STAFF REPORT

TO: Planning Commission
FROM: Nathan Fuerst, AICP, Consulting Planner
AGENDA ITEM: **Oak Land Middle School Improvements - Conditional Use Permit, Minor Subdivision, and Variance**
REVIEWED BY: Jason Stopa, Community Development Director
Sophia Jensen, City Planner

OAK-LAND MIDDLE SCHOOL ADDITION

OVERALL: EXISTING CONDITIONS AND DEMOLITION PLAN

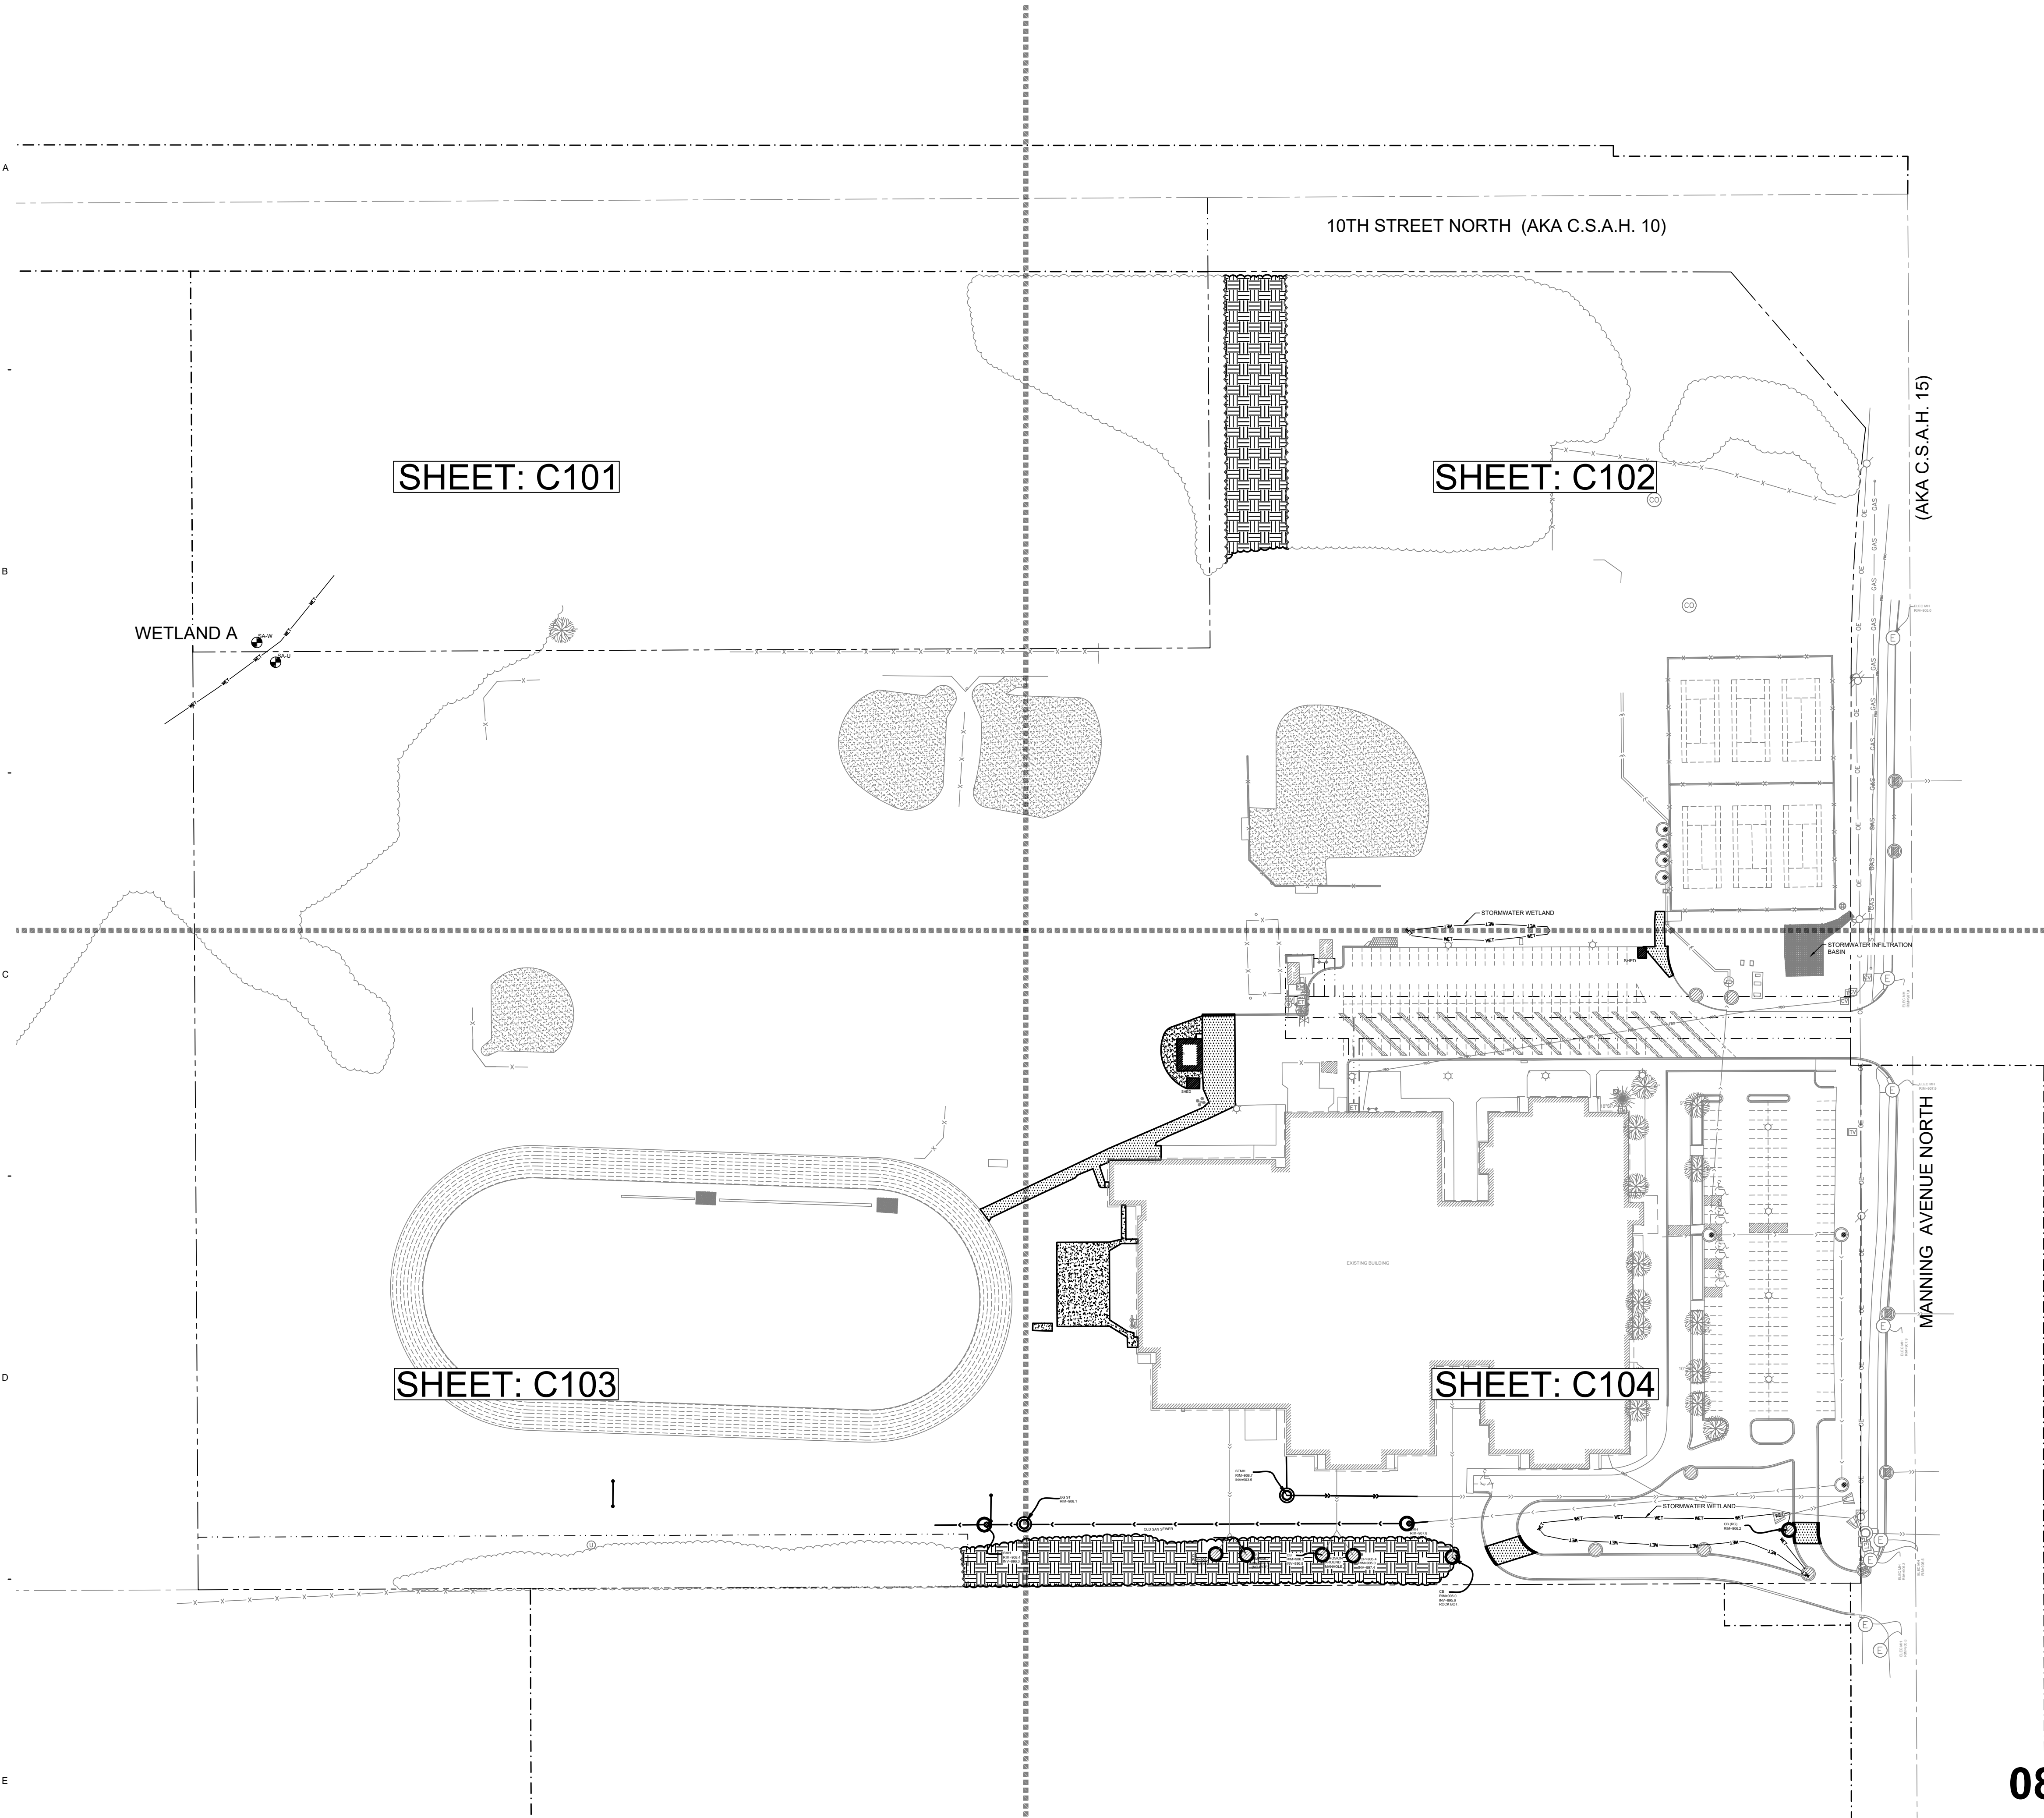
- A tree preservation plan was submitted, but requires the following adjustments prior to approval:
 - Sheet C100 shows tree protection fencing in the legend, but not on the plans. Please include this fencing on the plans and add the City Standard Detail for tree protection to this sheet or refer to it if placed elsewhere within the set.
